ADDENDUM No. 1

RFP No. 22-19

South State Street Reconstruction

SCALE	INCH
DRAWING NO. C11.2	
SHEET NO. OF

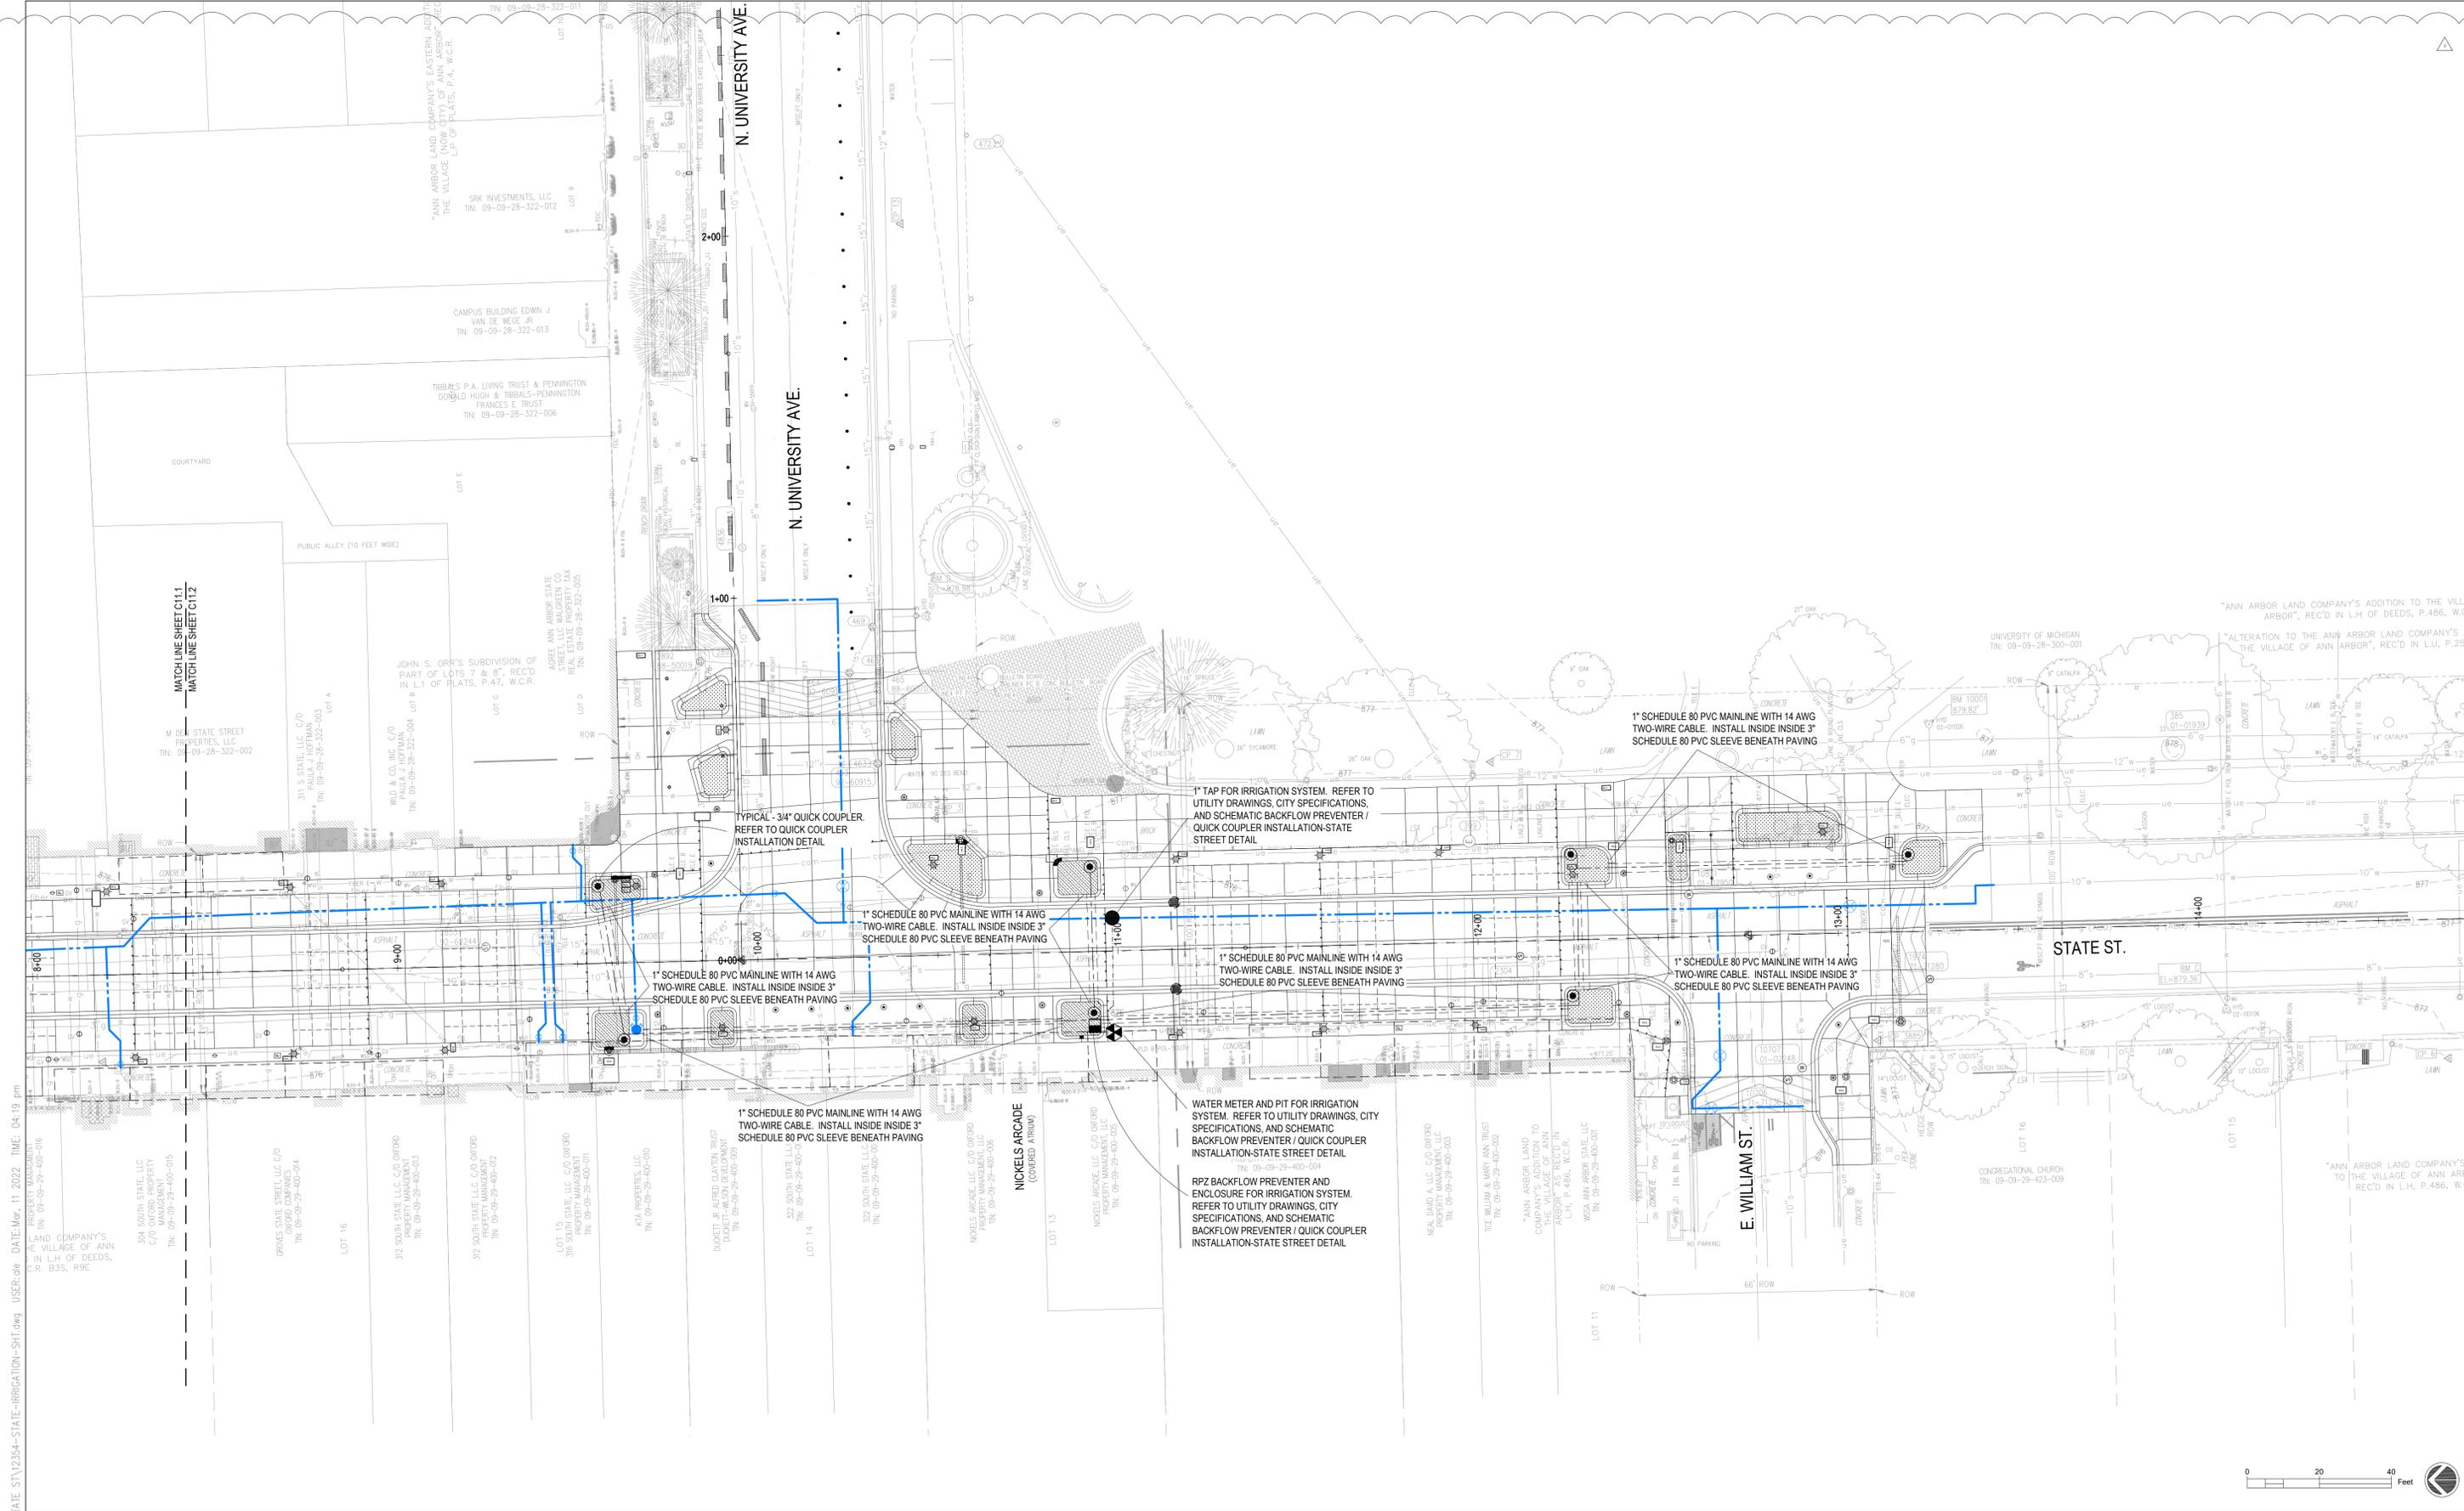
Pages 7-14 + Plans	This project is adding irrigation facilities, as outlined on the attached drawings (C11.1, C11.2, and C12.1), detailed specifications, and Bid Form.
Plans Only	The water main plans have been amended as outlined on the attached drawings, C6.2, C6.3, and C6.9.
Page 15 + Plans	The contractor is to furnish the Regulatory Street Signage to the City of Ann Arbor, as outlined on the attached drawings (C10.1, C10.2, C10.3, and C10.4), detailed specifications, and Bid Form. The City of Ann Arbor will install the signs with their own forces.
Pages 16-18 +Plans	<p>The material for pavement symbols has been changed from “OVLY, COLD PLASTIC” to “POLYUREA” for the following pay items-</p> <p>Item 259-03: Pavt Mrkg, Polyurea, Bike Arrow and Yield Sym. Item 259-04: Pavt Mrkg, Polyurea, Special Sym. Item 259-05: Pavt Mrkg, Polyurea, Bike Sym. Item 259-06: Pavt Mrkg, Polyurea, Sharrow Sym.</p> <p>This change is reflected on the attached plans (C10.1, C10.2, C10.3, and C10.4), detailed specifications, and Bid Form.</p>
